## **Proposal for the 03 series of amendments to Regulation No. 58 (Rear underrun protection)**

The text reproduced below was prepared by the expert from Germany based on the documents ECE/TRANS/WP.29/GRSG/2015/17 and the provisions given in documents ECE/TRANS/WP.29/GRSG-108-13 from CLCCR, ECE/TRANS/WP.29/GRSG-108-27 and GRSG-108-28 from OICA on rear underrun protection devices on heavy goods vehicles. The provisions in the document from CLCCR and OICA have been taken into account in this document as far as Germany can support the proposed amendments. In addition the wording gross vehicle weight was replaced by maximum mass throughout the entire text, as this wording is defined in section 2 of Regulation no. 58.

Figure 1

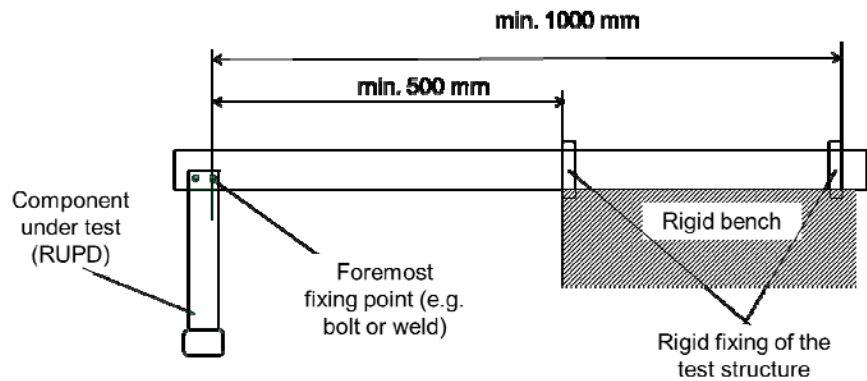
Paragraph 1.2., amend to read (including a new Figure 1):

"1.2. In the case of paragraphs 1.1.2., ~~and 1.1.3~~ the parts ..... of the vehicle chassis ~~or to the rigid test bench~~ shall be ..... on the vehicle. **The part of the chassis can be fixed on a test bench as shown in Figure 1, representing the minimum requirements to be fulfilled. The structures used as side rails shall be representative of the chassis of vehicles for which the underrun protection system is intended.**

**The distance of the foremost fixing point of the RUPD from the rigid test bench shall not be less than 500 mm. If a diagonal strut is used to support the RUPD, this distance shall be measured between the foremost fixing point of the strut to the side rail structures and the rigid test bench.**
